APPLICATION FOR PERMIT TO DRILL OR REENTER

2. Name of Operator EOG RESOURCES INCORPORATED		8. Lease Name and Well No. HONEY BUN 6 FED COM
3a. Address 1111 BAGBY SKY LOBBY 2, HOUSTON, TX 77002	3b. Phone No. (include area code) (713) 651-7000	9. API Well No. 30-015-54243

**EOG RESOURCES, INC.
HONEY BUN 6 FED COM #723H**

PECOS DISTRICT DRILLING CONDITIONS OF APPROVAL

Proposed Wellbore
Design A

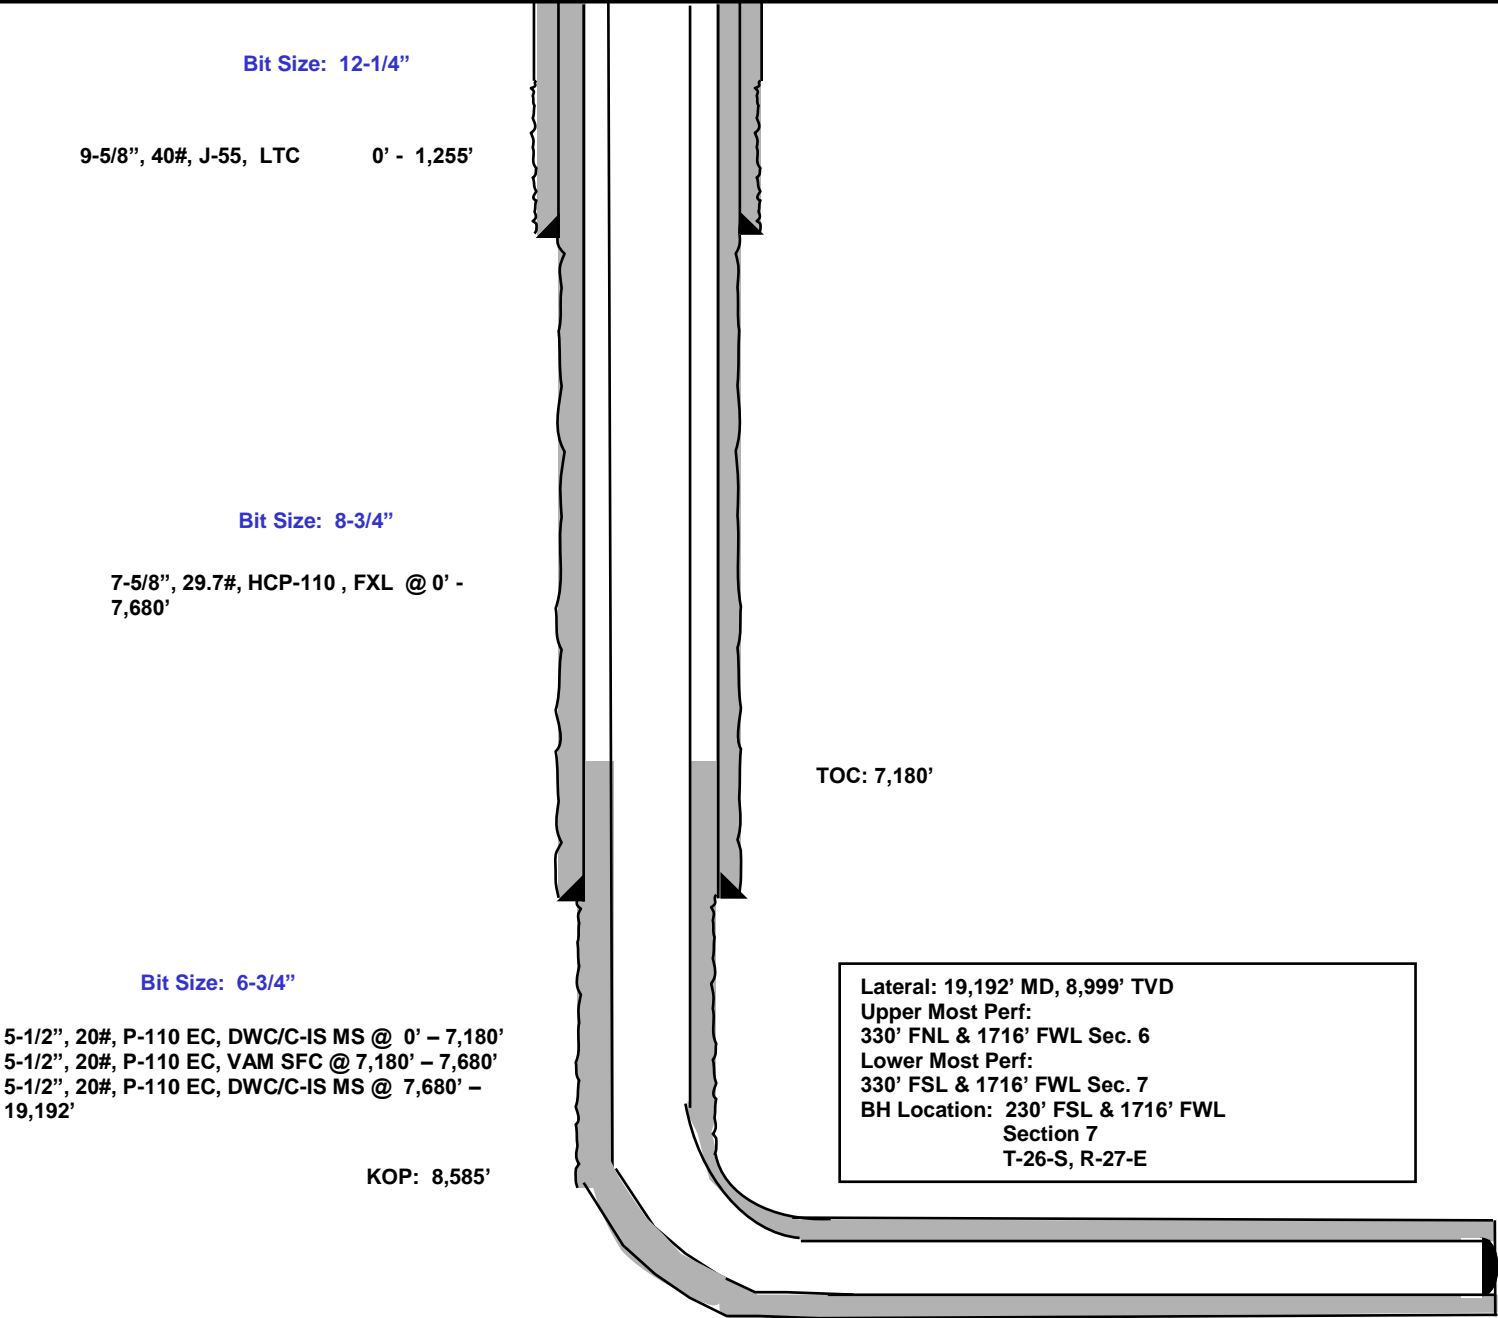
3. The minimum required fill of cement behind the **5-1/2** inch production casing is:
 - Cement should tie-back at least **200 feet** into previous casing string due to operator not meeting casing clearance requirement per 43 CFR 3170. Operator shall provide method of verification.

Proposed Wellbore
Design B

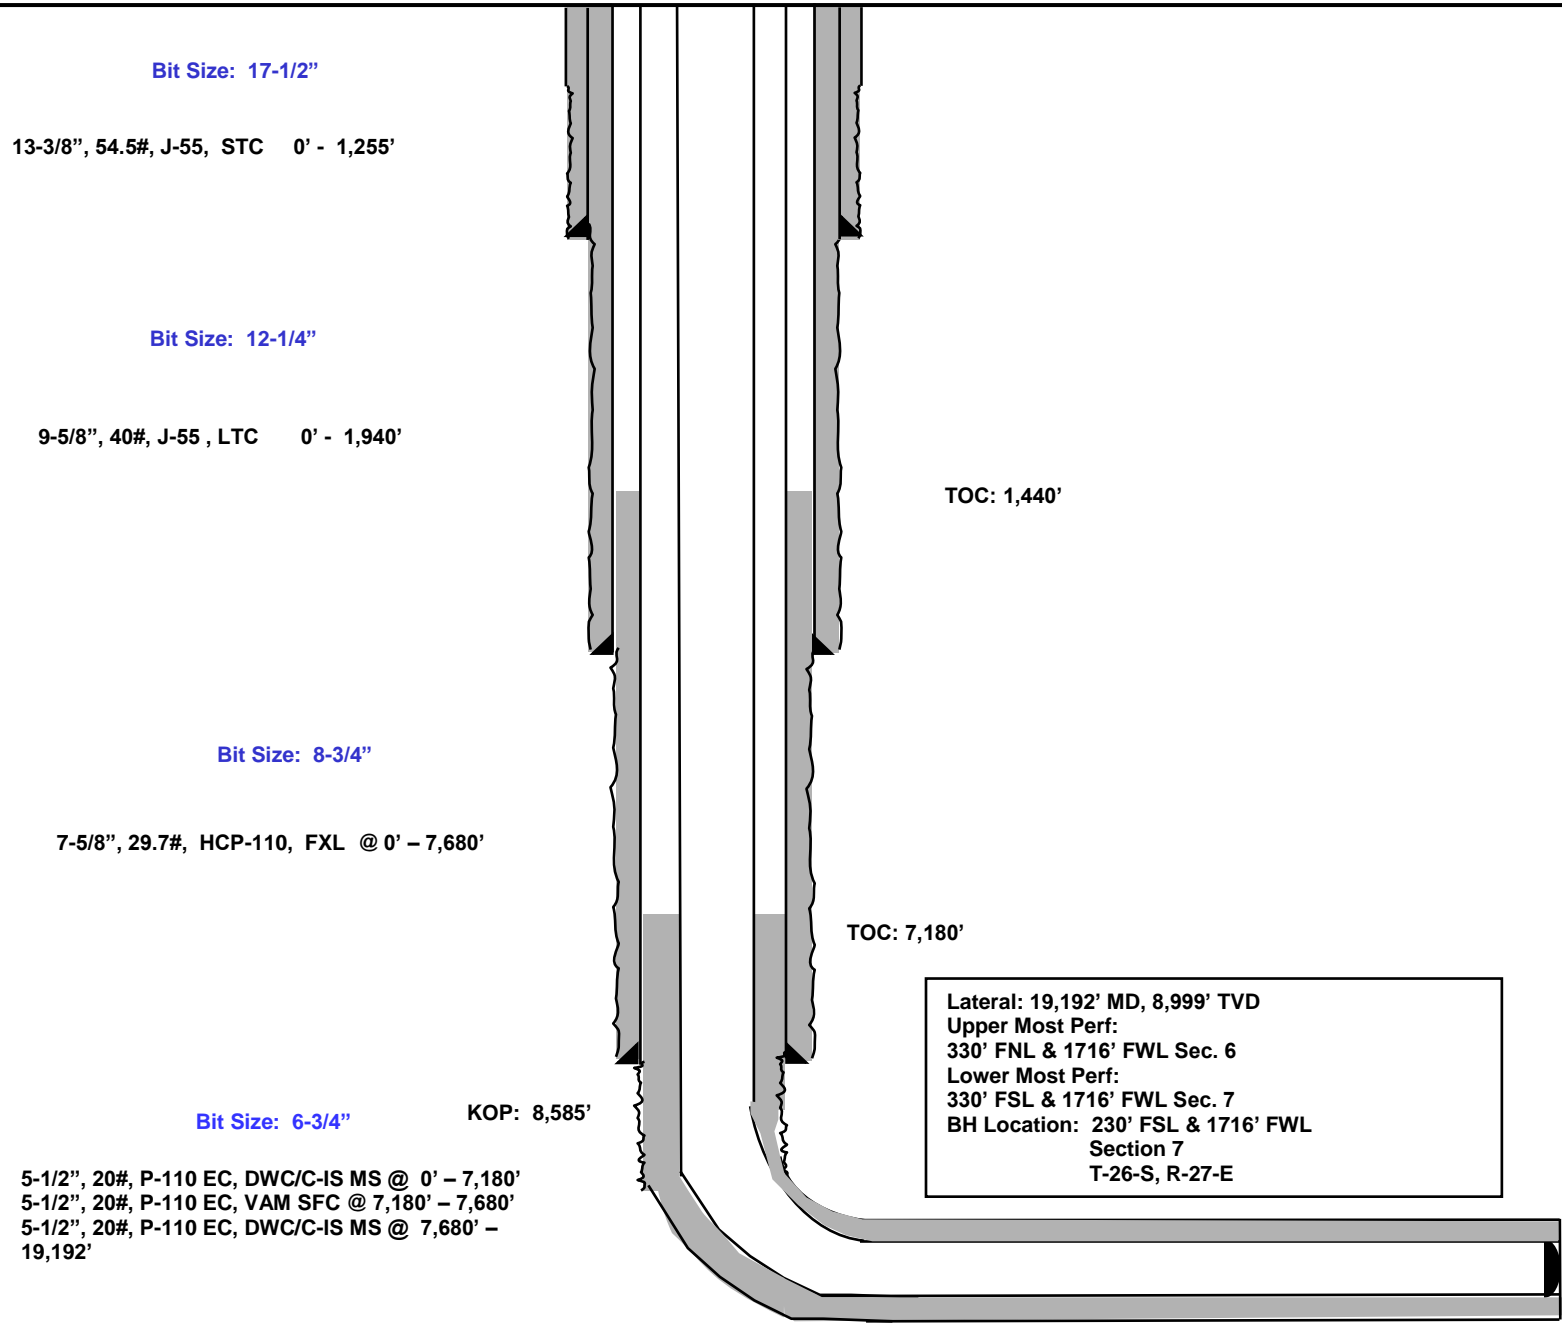
Operator is only approved for Design A. Design B is not to be utilized. If Design B is needed or any other change, please submit a NOI sundry to make the changes.
